From: Woodlan, Don [Donald.Woodlan@luminant.com]
Sent: Thursday, April 28, 2011 10:33 AM
To: Galvin, Dennis
Cc: Monarque, Stephen; Valentin, Milton; ComanchePeakCOL Resource; russell_bywater@mnes-us.com; 'tapia_joseph@mnes-us.com'; Conly, John; Evans, Todd
Subject: 2011-04-28 Follow-up on RAI 3.7.3-4, Clarifying Discussion Material
Attachments: image001.gif; 2011-04-27 CPNPP Clarifying Discussion Material re 3-7-3-4 Hydrodynamic pressure vertical ground motion.doc

Response to follow-up to RAI Question 3.7.3-4

Figure 3.7.3-4A-1 – Comparison of Hydrodynamic Lateral Pressure based on ASCE 4-98 and Method Presented in Ref. 2 by Bandyopadhyay et. al. for 1g Vertical Spectral Acceleration

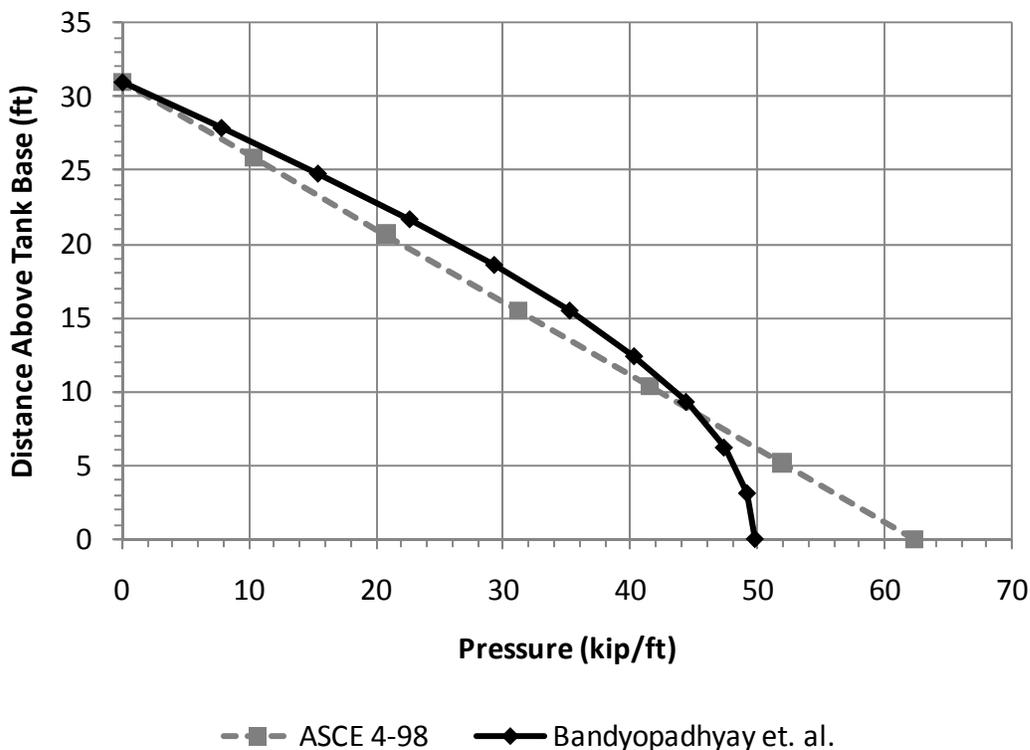
1. Luminant should provide a technical argument justifying why the peak of the base slab ISRS necessarily bounds the peak of the basin wall ISRS
2. What are the geometry and configuration of the basin walls being considered, and what is the connection to the geometry and configuration of the base slab being considered? How are the frequencies of the walls and base slab related?

A comparison of the pressures calculated using the ASCE 4-98 and Bandyopadhyay equations was performed considering a 1g vertical spectral acceleration and the comparison is presented in Figure 3.7.3-4A-1. The comparison shows that both methods result in similar hydrodynamic lateral pressures.

Figure 3.7.3-4A-2 – Rectangular Hydrodynamic Regions of the UHS (Figure 3KK-4 from FSAR)

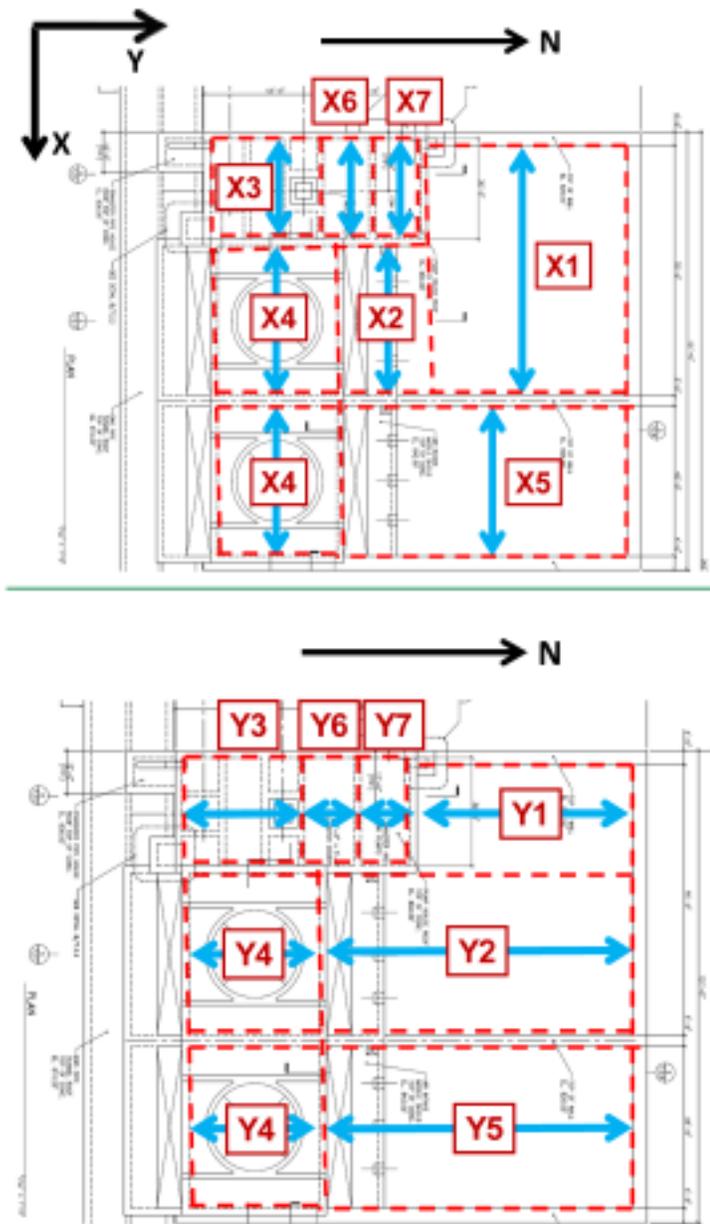
2. What are the geometry and configuration of the basin walls being considered, and what is the connection to the geometry and configuration of the base slab being considered? How are the frequencies of the walls and base slab related?

3. There are several walls in the UHSRS including external walls and internal walls that separate different rectangular regions. Luminant should identify the walls being considered and describe how the use of the base slab spectrum is conservative for each case.

- The geometry and configuration of the basin walls are shown in Figure 3KK-4 of the FSAR (Figure 3.7.3-4A-2). The basin consists of four external walls with a number of internal walls including those that supporting the pump house and cooling towers. The external walls are primarily supported on the basin slab and three sides at intersections with other walls. At the pump house and cooling tower region, some walls also have support along the top edge.

- All external basin walls were considered in the analysis. Use of the base slab spectrum is described in the main response above.
4. It would be very helpful if Luminant were to provide a stronger physical argument for the use of the base slab spectrum.
